Documentation Description: Nonconformance Report - C-03078-V

NONCONFORMANCE REPORT

16 MCR NO. C-03078-V
 17 DATE ISSUED 4-23-84 18 REV 0
 19 PAGE 1 OF 3

1 ITEM LOCATION
 MOD 120D - ELEV 584' 1' NORTH OF SOUTH WALL, 6'8" EAST OF WEST WALL, ON CEILING.

SKETCH

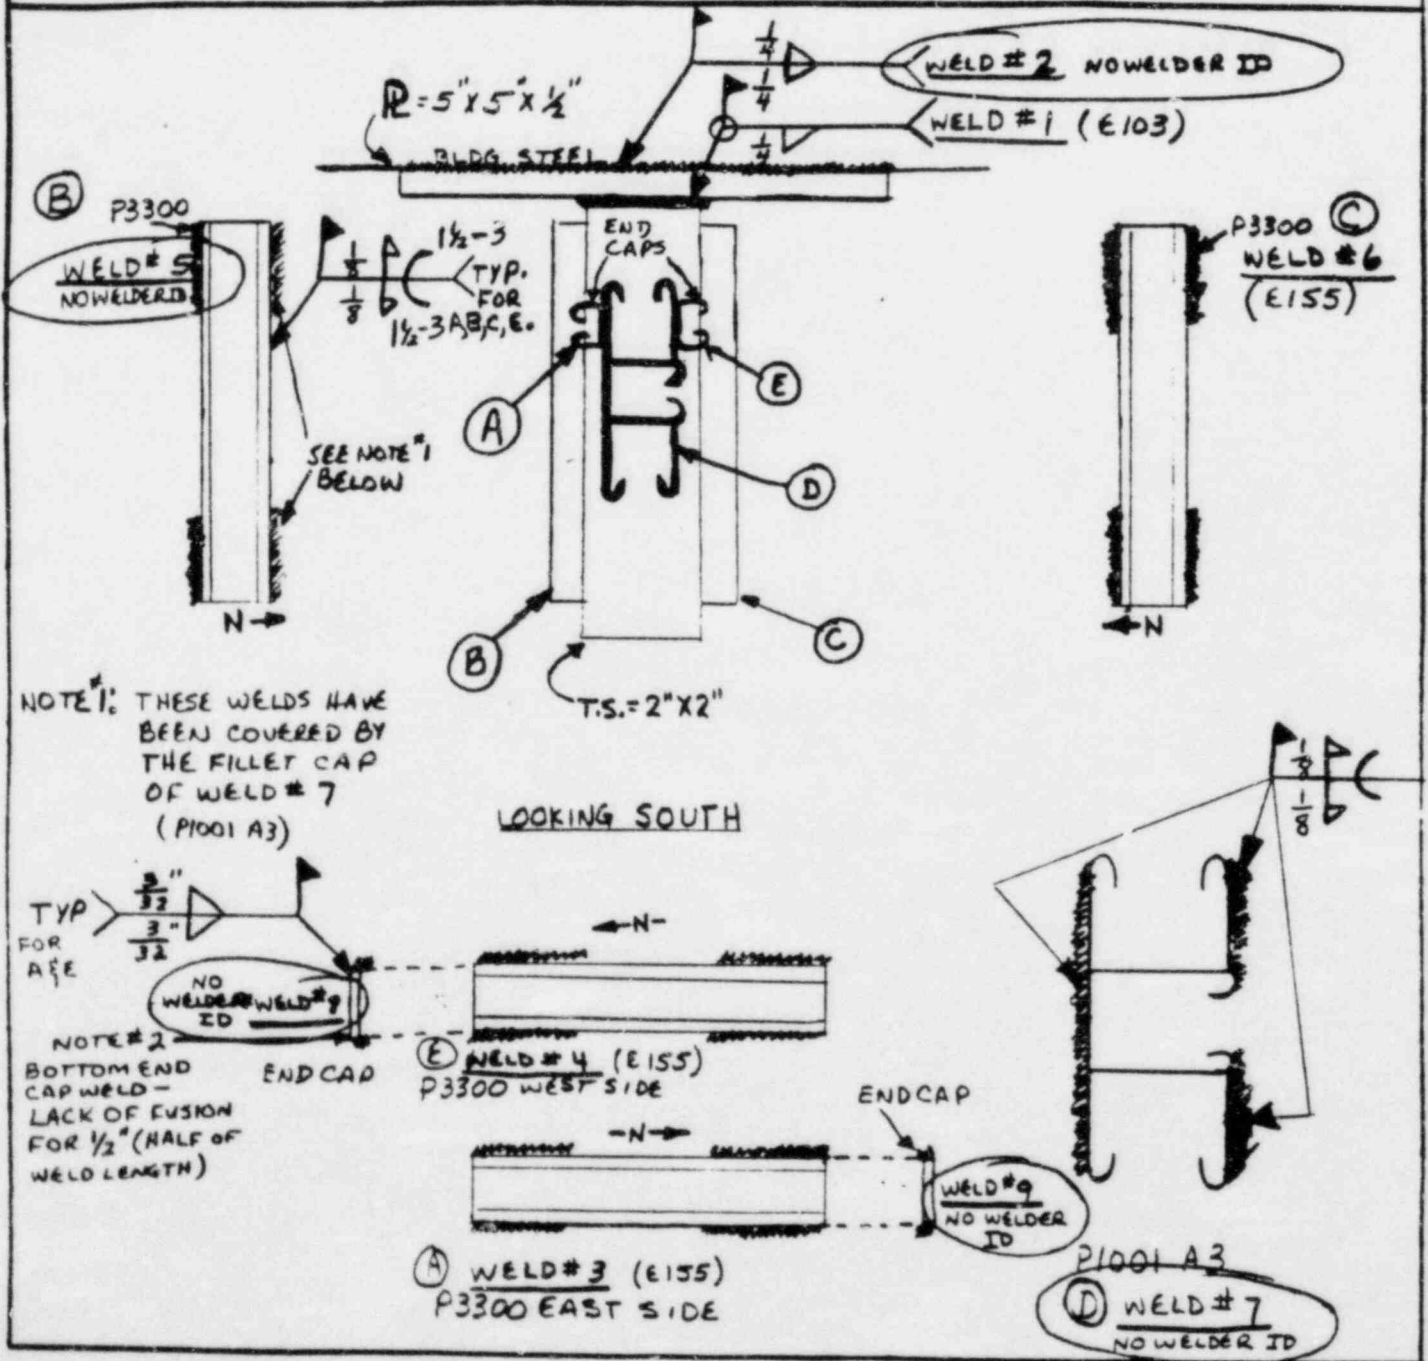
13 NONCONFORMANCE CONTRARY TO THE ABOVE REQUIREMENTS.
 ① WELDS #3, 4, 5, 6 AND 7 ARE NOT PREQUALIFIED (SEE ATTACHED DRAWING.)
 ② WELD #8 HAS LACK OF FUSION FOR $\frac{1}{2}$ " OF ITS 1" LENGTH. (SEE ATTACHED DRAWING.)
 ③ WELDS # 2, 5, 7, 8 AND 9 DOES NOT HAVE WELDERS ID. (SEE ATTACHED DRAWING.)

NOTE WELD #5 NORTH WELDS WERE COVERED WITH WELD METAL WHEN FILLET CAP FOR WELD #7 WAS APPLIED, CONSEQUENTLY THESE TWO COULD NOT BE INSPECTED.

NOTE #1: THESE WELDS HAVE BEEN COVERED BY THE FILLET CAP OF WELD #7 (P1001 A3)

NOTE #2: BOTTOM END CAP WELD - LACK OF FUSION FOR 1/2" (HALF OF WELD LENGTH)
